SAN FRANCISCO PLANNING DEPARTMENT

Preliminary Project Assessment

Date: December 21, 2016
Case No.: **2016-012529PPA**
Project Address: 2214 Cayuga Avenue & 3143 Alemany Boulevard
Block/Lot: 7146/001, 034
Zoning: Neighborhood Commercial, Cluster (NC-1) Zoning District
40-X Height and Bulk District
Area Plan: N/A
Project Sponsor: Jeremy Schaub, Gabriel Ng Architects Inc.
(415) 682-8060
Staff Contact: Christopher Espiritu – (415) 575-9022
Christopher.Espiritu@sfgov.org

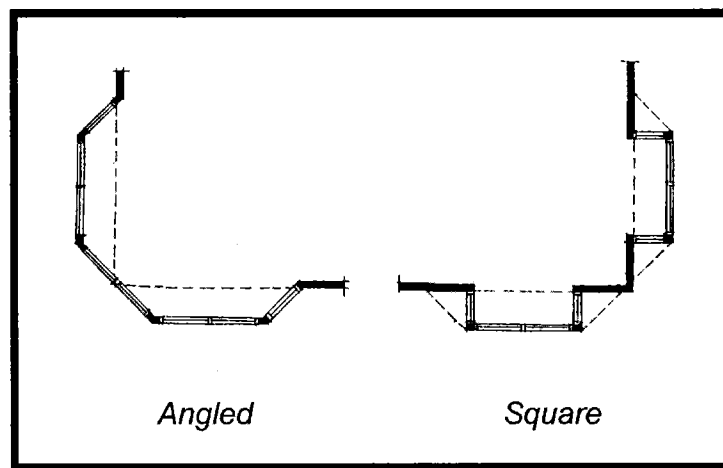
2. **Permitted Obstructions.** Section 136(c) permits bay window projections into the required open area provided such projections shall be limited to three feet, provided that projection over streets and alleys shall be further limited to two feet where the sidewalk width is nine feet or less, and the projection shall in no case be closer than eight feet to the centerline of any alley. Additionally, each bay window or balcony over a street or alley, setback or rear yard shall also be horizontally separated from interior lot lines (except where the wall of a building on the adjoining lot is flush to the interior lot line immediately adjacent to the projecting portions of such bay window or balcony) by not less than one foot at the line establishing the required open area, with such separation increased in proportion to the distance from such line by means of a 135-degree angle drawn outward from such one-foot dimension, reaching a minimum of four feet along a line parallel to and at a distance of three feet from the line establishing the required open area

The proposed bay windows do not all appear to comply with the interior lot separation. Also, the proposed corner bay windows exceed the maximum allowed dimensions. See diagram below for what the size limits for corner bay windows are:
